Access Compliance Report

Public Rights-of-Way

Intersection ID: 10025402	Main Street: E_BLAND_ST	Cross Street: N/A	Location: NE
ADA ID: DABFE58881A4	Ramp Type: BlendTrans1	Initial Pass/Fail: Pass	Overall Compliance: No
		Severity Score: 2.5

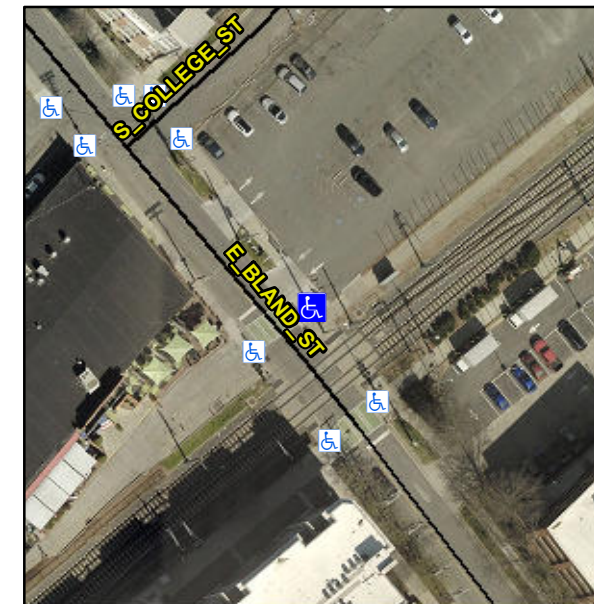
Not Found, R304.2.3

Compliance	Description	Data	Compliance	Description	Data
N/A	Ramp Length (in)	95.0	Yes	BlendTrans Slope (%)	1.2
Yes	Ramp Width (in)	96.0	Yes	BlendTrans XSlope (%)	1.7
N/A	Flare Type LT	Sloped	N/A	Flare Type RT	Sloped
No	Flare Slope LT (%)	11.0	Yes	Flare Slope RT (%)	0.4
N/A	Flare Traversable LT?	Yes	N/A	Flare Traversable RT?	Yes
Yes	Landing Length (in)	95.0	Yes	DWS Provided?	Yes
Yes	Landing Width (in)	96.0	Yes	DWS Contrast?	Yes
Yes	Landing Slope (%)	0.7	Yes	DWS Length (in)	24.0
Yes	Landing X Slope (%)	0.8	Yes	DWS Full Width?	Yes
N/A	Landing Curb? (Y/N)	Yes	Yes	DWS Offset (in)	1.0
N/A	Shared Landing?	Yes			
Yes	Gutter Ponding?	No	Yes	Gutter Slope (%)	3.9
Yes	Gutter Lip Ht (in)	0.0	Yes	Gutter X Slope (%)	1.6
N/A	Painted X Walk1?	Yes	N/A	Painted X Walk2?	N/A
	X Walk 1 Direction	To SW		X Walk 2 Direction	N/A
	X Walk 1 Width (in)	161.0		X Walk 2 Width (in)	N/A
	X Walk 1 Slope (%)	1.6		X Walk 2 Slope (%)	N/A
	X Walk 1 X Slope (%)	1.7		X Walk 2 X Slope (%)	N/A

Remove & Replace Curb Ramp With Two New Directional Ramps or Equivalent.
